# MULTIPLE PLAY MANUAL TURNTABLES

## SERVICE BULLETIN

SUBJECT: NEW CARTRIDGE MOUNTING SCREWS-ALL MODELS

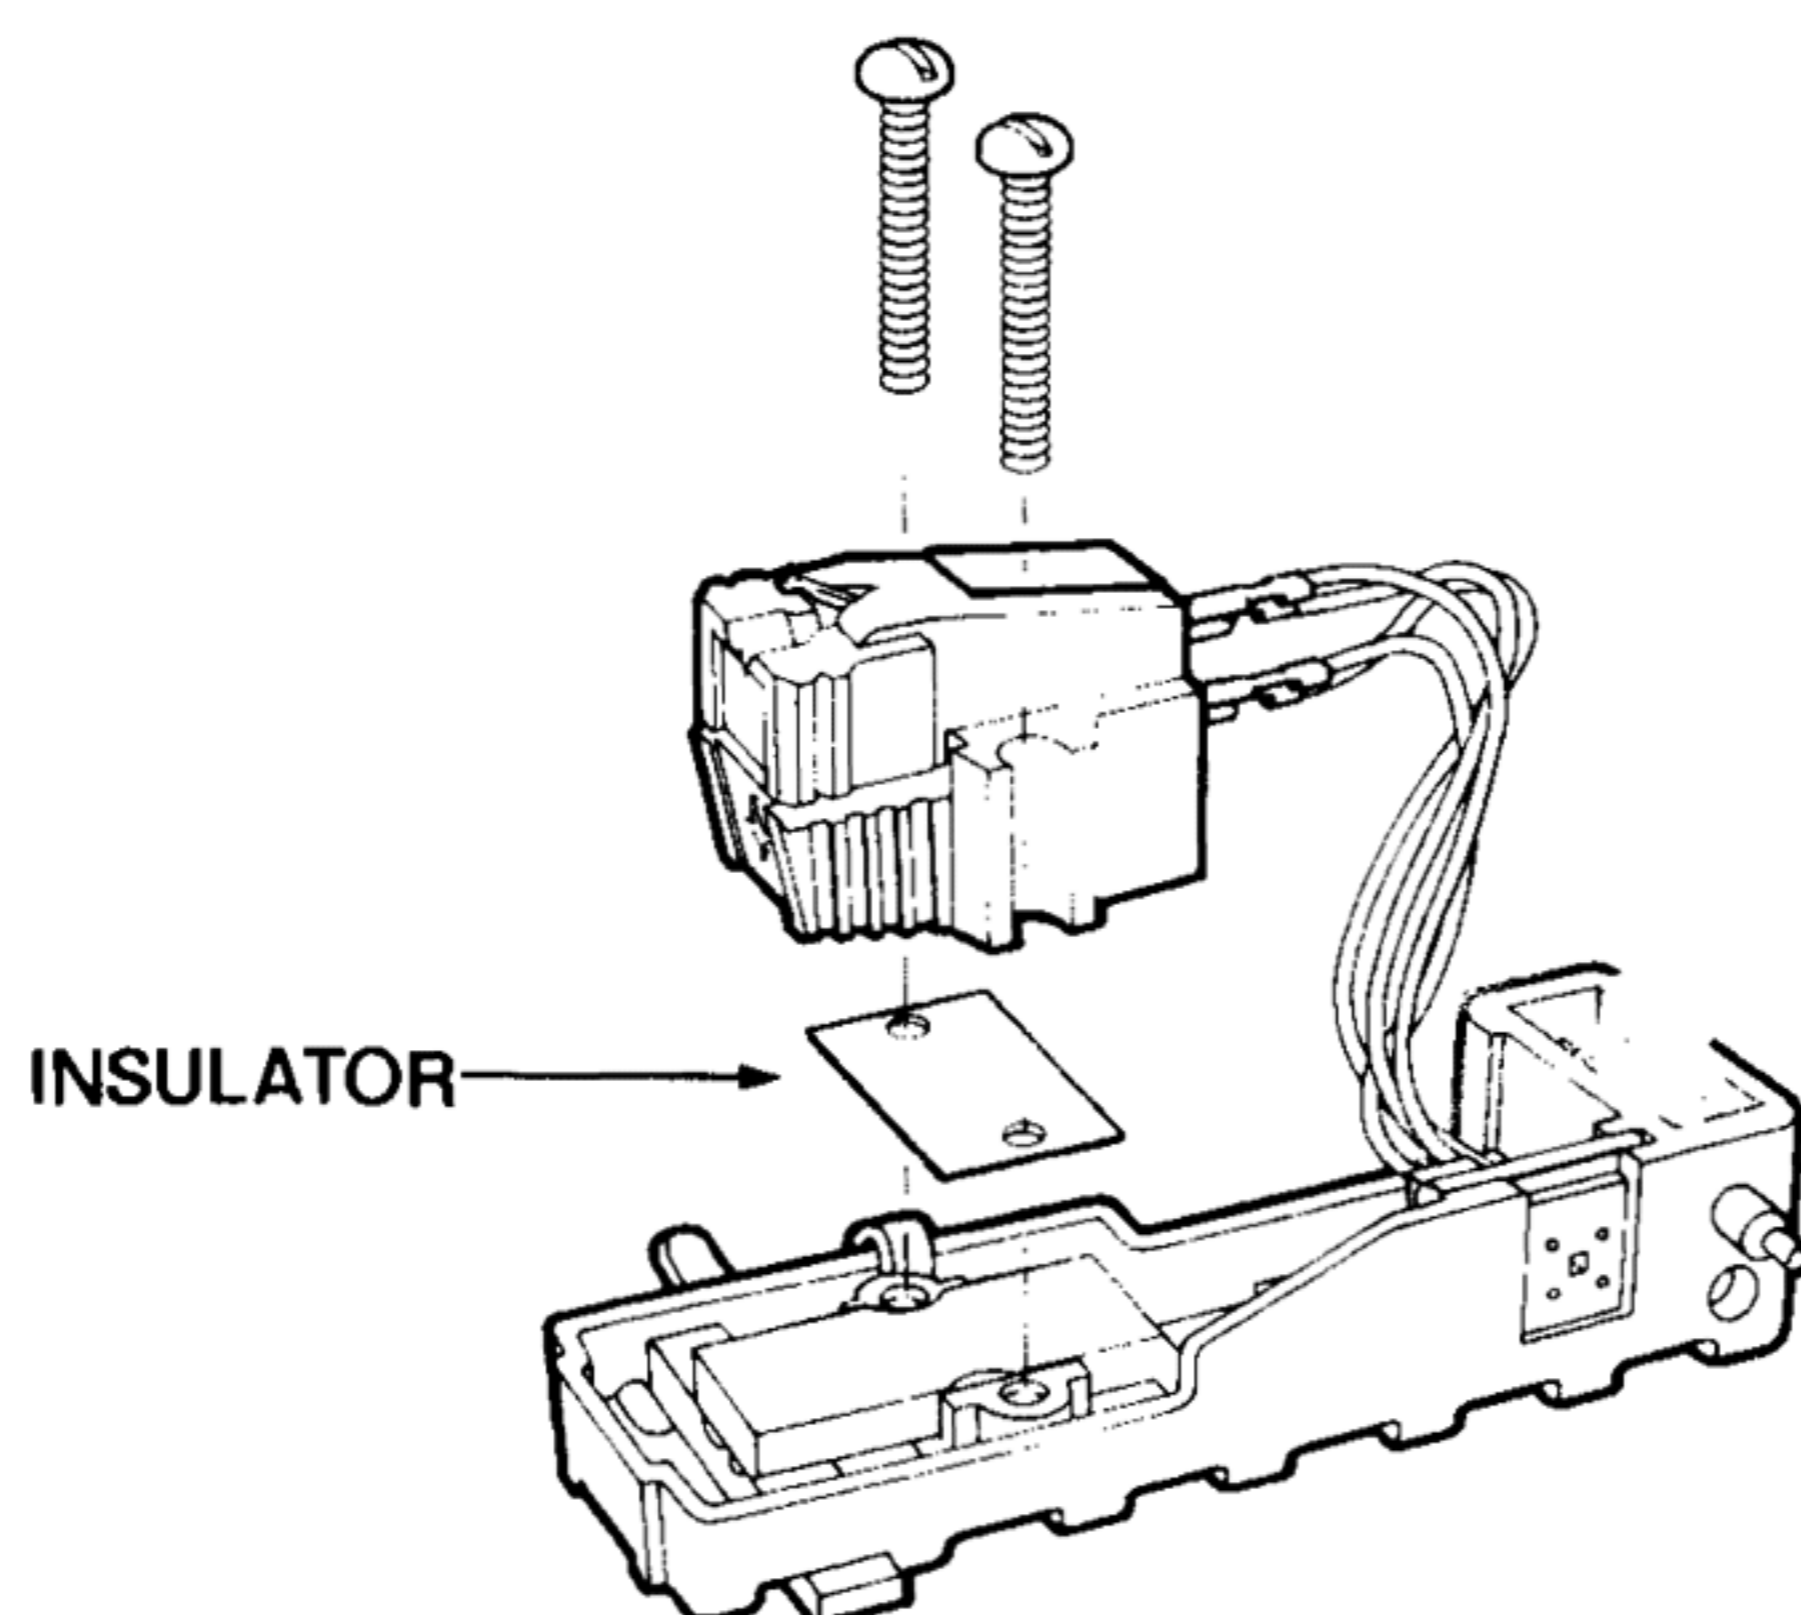
To eliminate this problem, and at the same time, retain the advantages of a shielded pickup head, we have changed our cartridge mounting hardware. Instead of metal screws, B·I·C units will shortly be supplied with nylon screws (non-conductive). Nylon screws are also lower in mass, thus further reducing the tonearm mass of B·I·C units.

We will also supply a non-conductive spacer which must be used between the cartridge and the cartridge mounting plate in order to isolate the cartridge from the mounting bracket (see diagram). If the cartridge is mounted, using the isolation strip and nylon screws, the possibility of ground loops will be completely eliminated.

SUBJECT: PROGRAMMER SKIPPING FROM ONE TO OFF POSITION

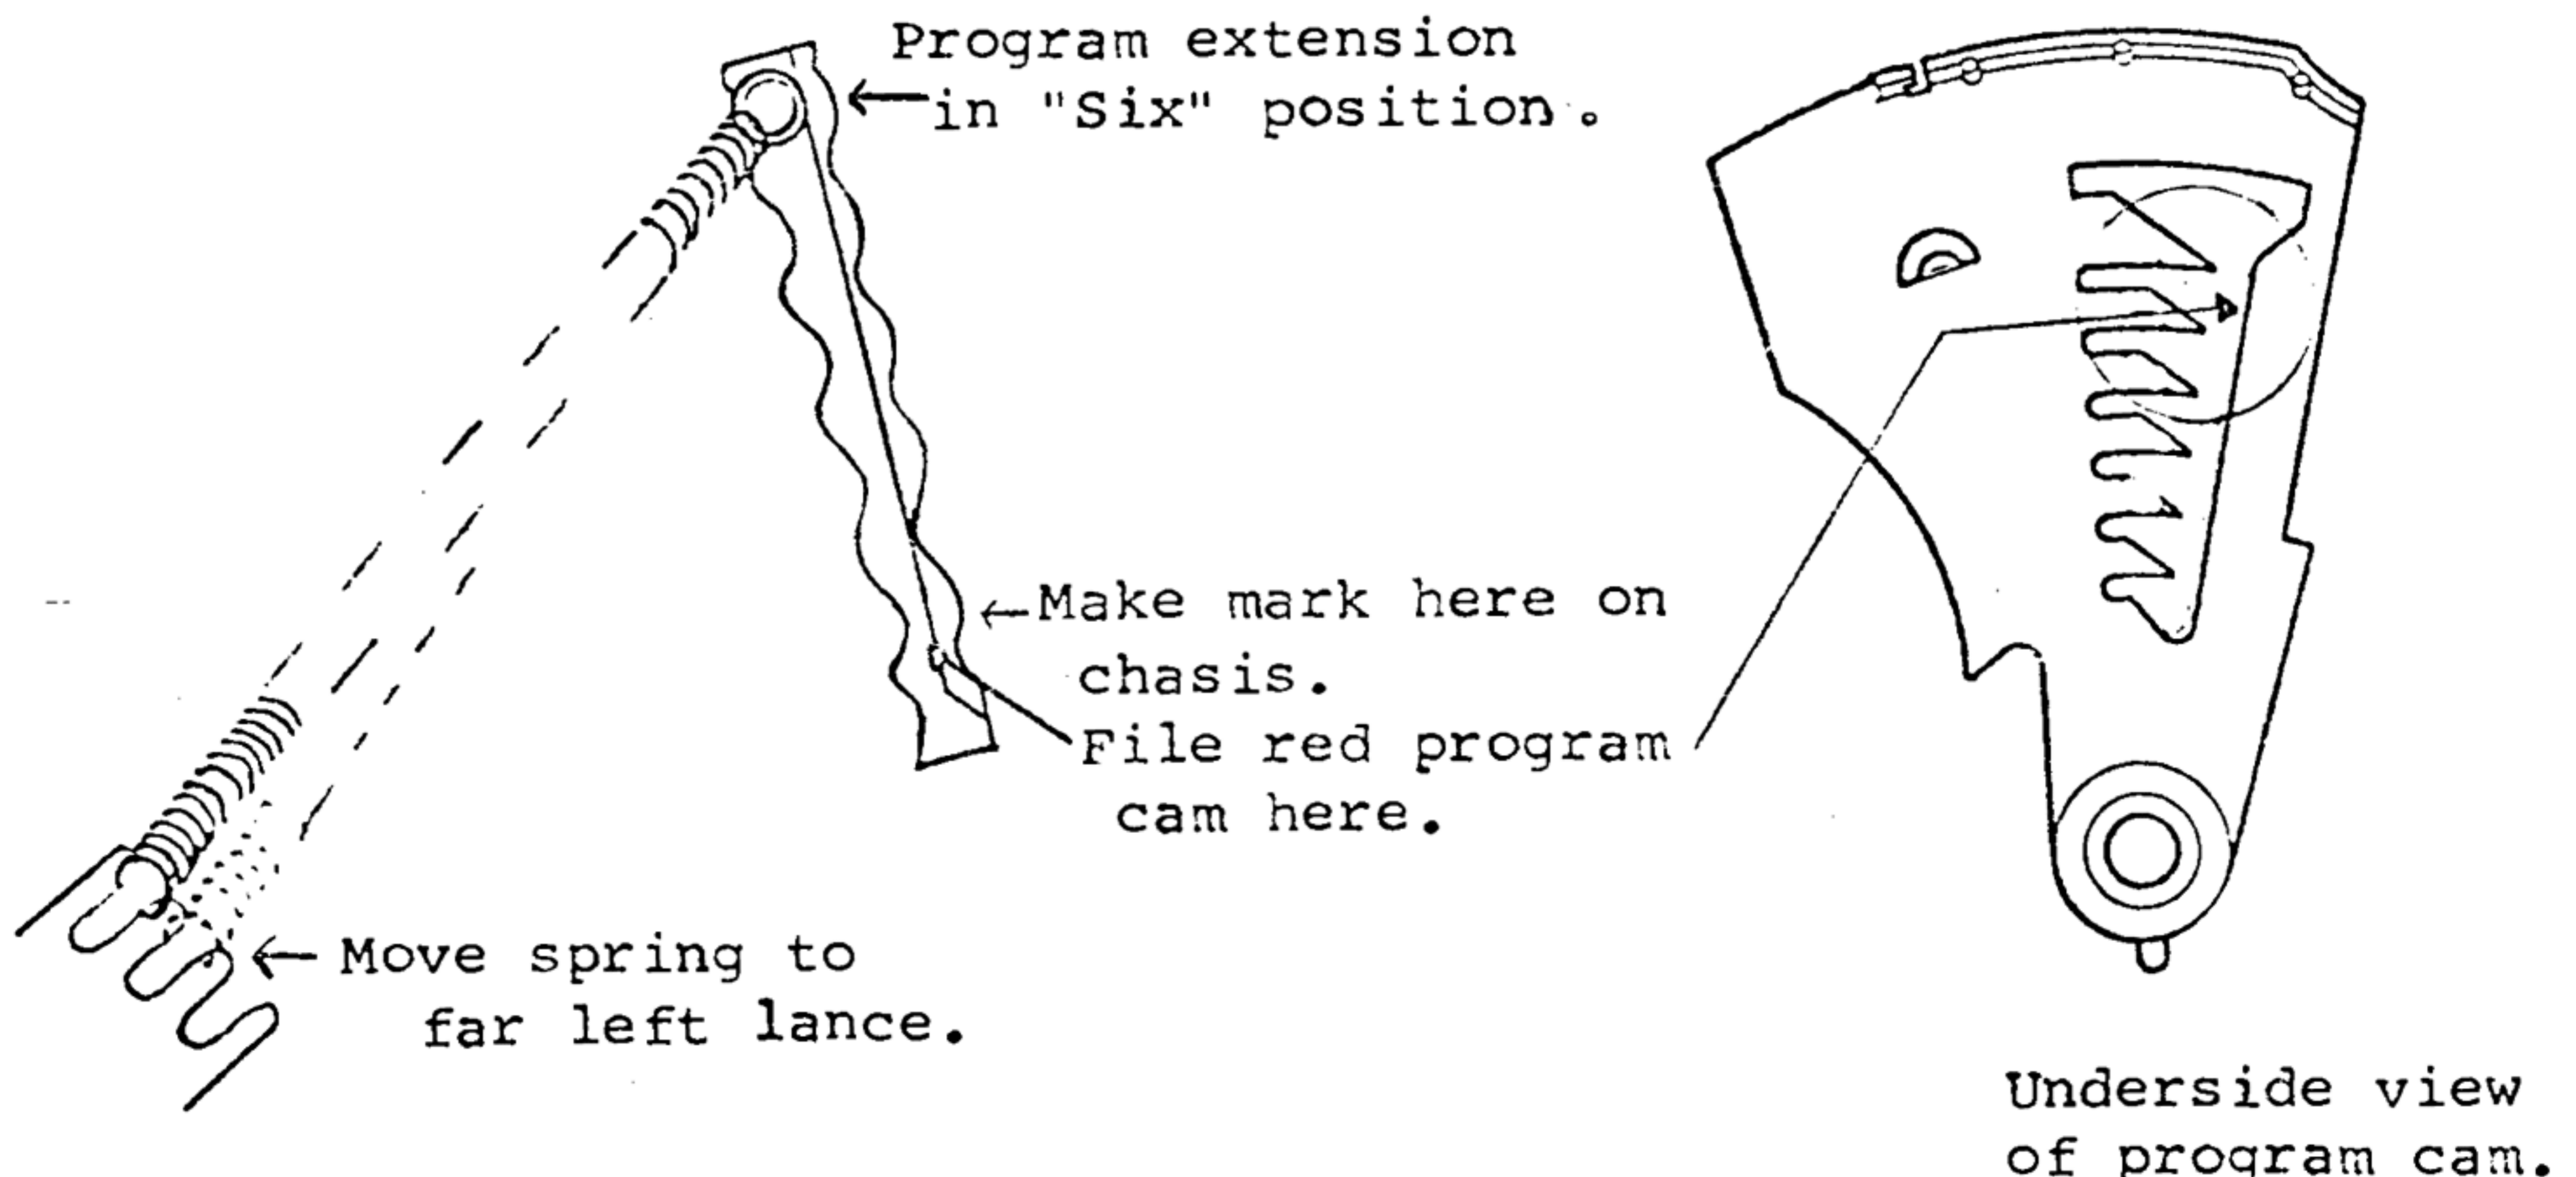
To further improve the reliability and feel of the programmer, the programmer cam plate shown on the attached diagram was changed to a Lexan material commencing on Date Code 7603 (third week of January). It was determined on Date Code 7605 (fifth week of 1976) that the properties of Lexan could contribute to the programmer skipping from One to "Off" position. This is due primarily to the difference in co-efficient of friction between the old part and the Lexan part.

Commencing Date Code 7606, the Lexan programmer plate was modified to insure total reliability. If you encounter a unit that skips from One to "Off" position, please follow the detailed instructions on the attached sheet and the problem will be totally eliminated.

1. Remove platter.
2. Place program selector in the "One" position.
3. The white program extension extends up through the unit plate. Mark the area where this extension is resting against the red program cam.
4. Move the program selector up to the "Six" position.
5. Using a small file or emery board, rough up the red program cam on the inside edge in the area of the mark. You should be filing straight up and down through the unit plate. See diagram.
6. Move the program spring to the far left tooth notched into the unit plate. See diagram.
7. Replace platter.

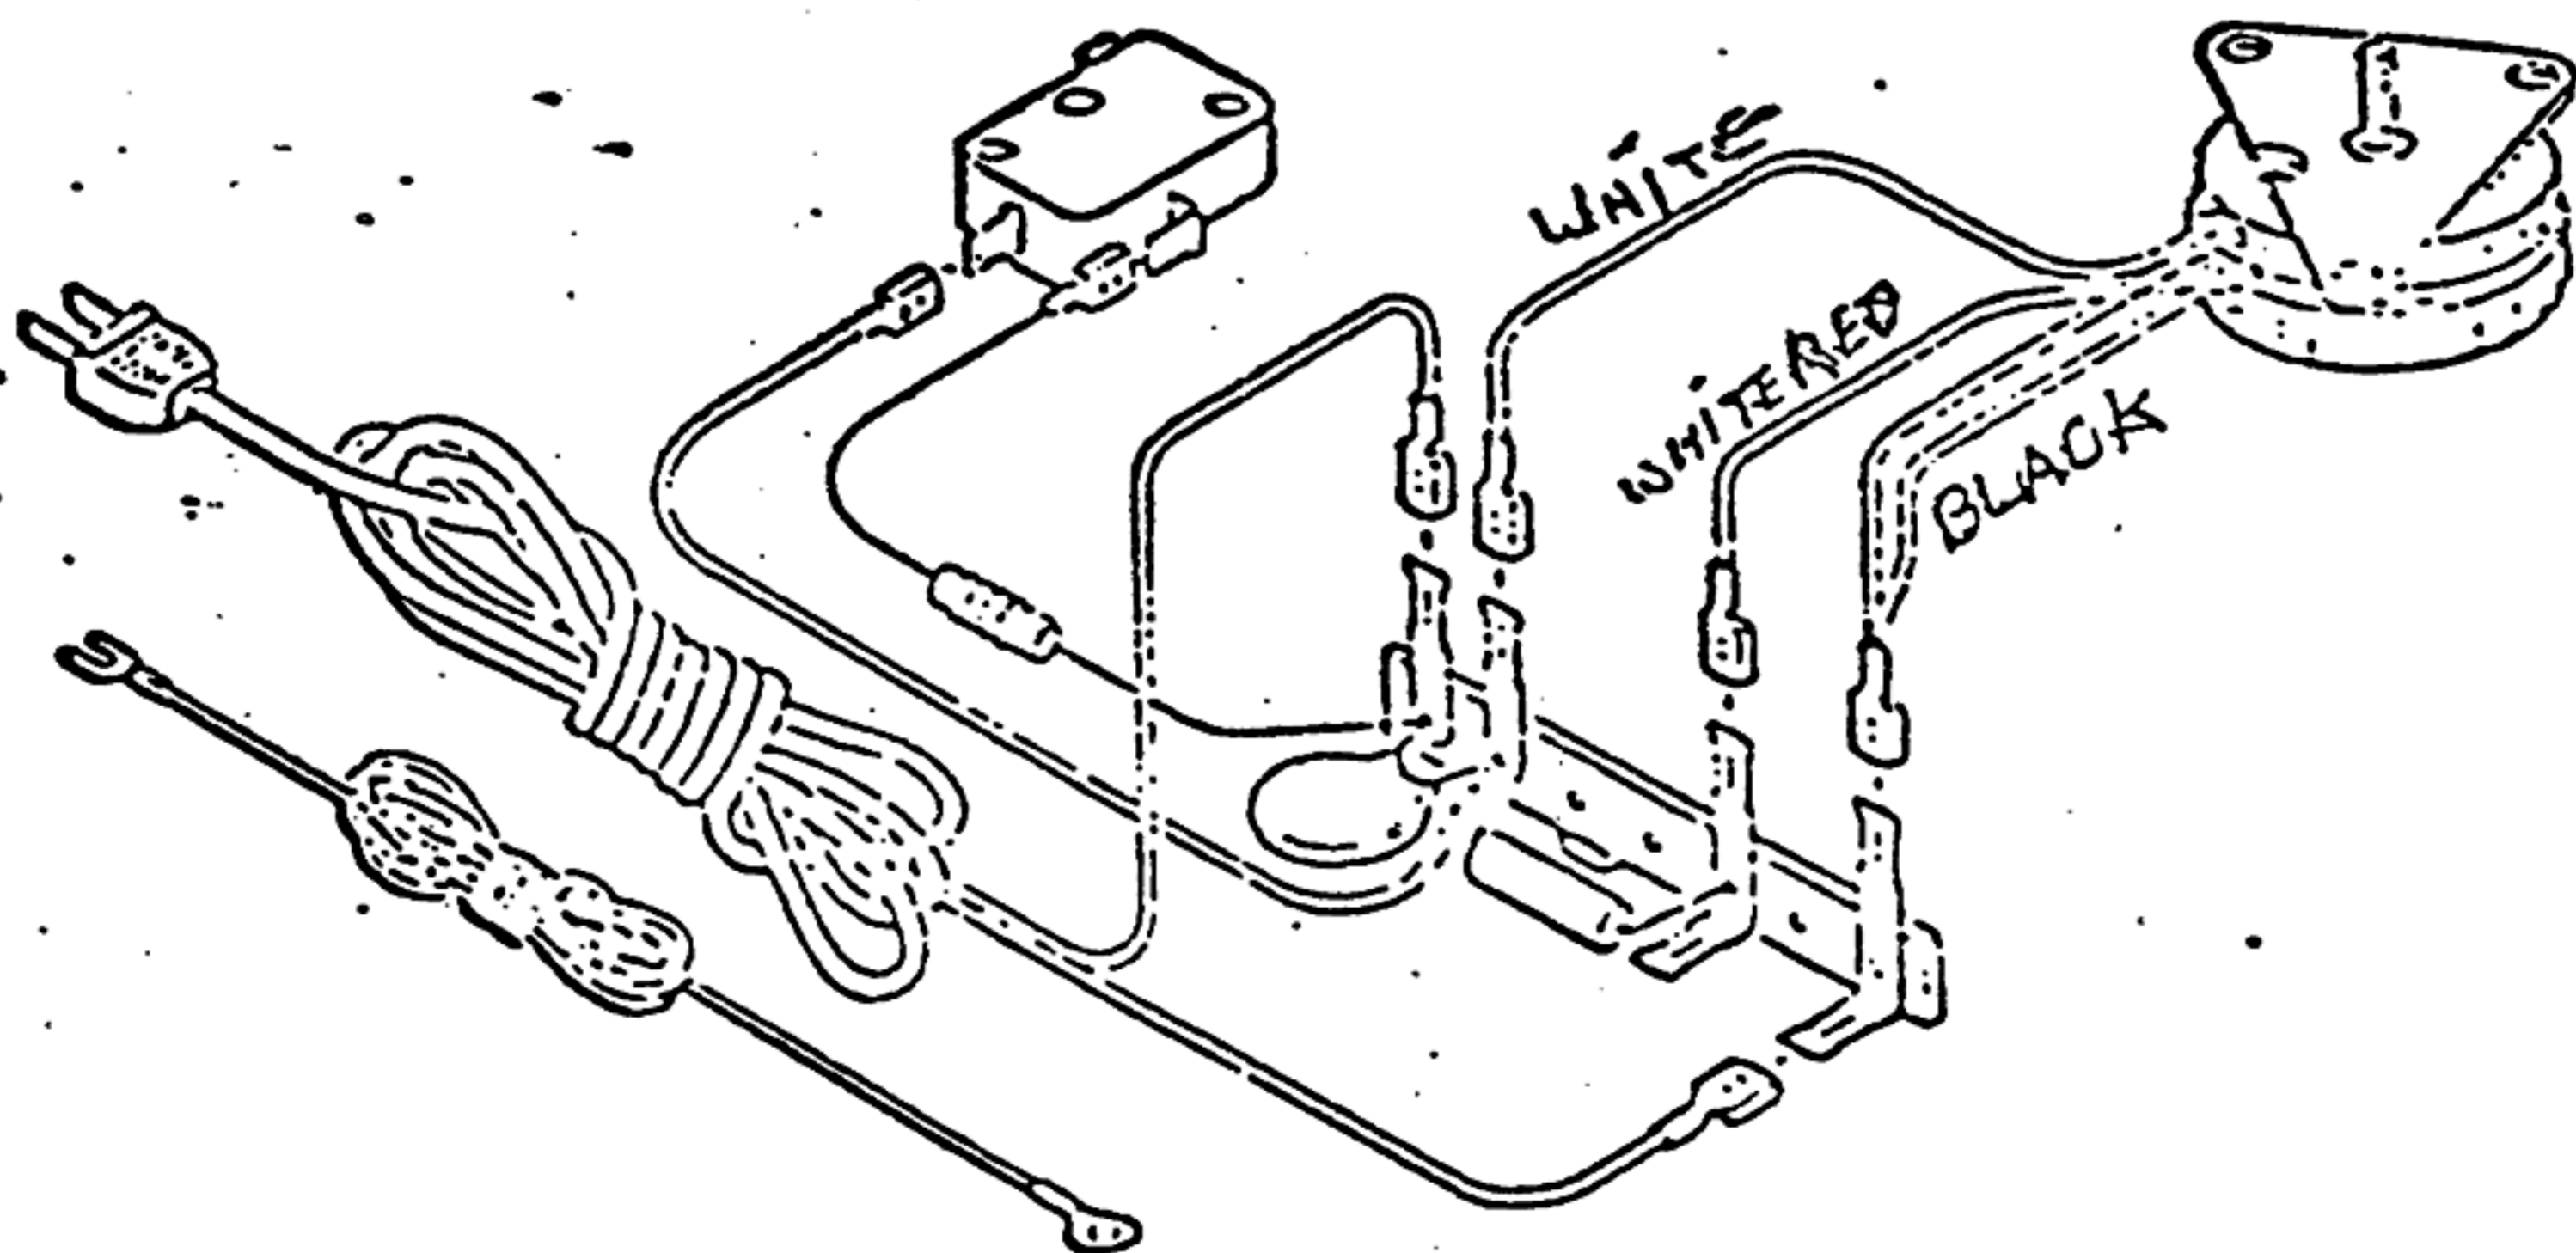
1. Tonearm moves to the right when cueing or just before landing on record in automatic.
2. Stylus pops two or three times when landing on record.

1. Initial 15 degree tracking angle adjustment not properly set.
2. Brake pin releasing too soon or too late.

1. Using the setting gauge supplied with each unit, recalibrate the tracking angle adjustment. (Listed under "Cartridge Angle Adjustment" in the Owner's Manual.)
2. Adjust brake pin.

If the tonearm moves to the right too soon, place either end of the wrench on the two flats at the top of the lift pin (ref. #132 on the 980 Blownup Diagram). The lift pin is the silver colored pin that lifts the tonearm gimbal during automatic play and when cueing.

3. Turn the lift pin in a clockwise direction if the cueing brake pin releases too soon and counter-clockwise if it releases too late. After performing this adjustment, it may be necessary to re-adjust the pickup height as shown in the Owner's Manual under the heading of "Tonearm Height". Also, re-adjust stylus pressure and anti-skating to conform to the cartridge manufacturer's specifications.
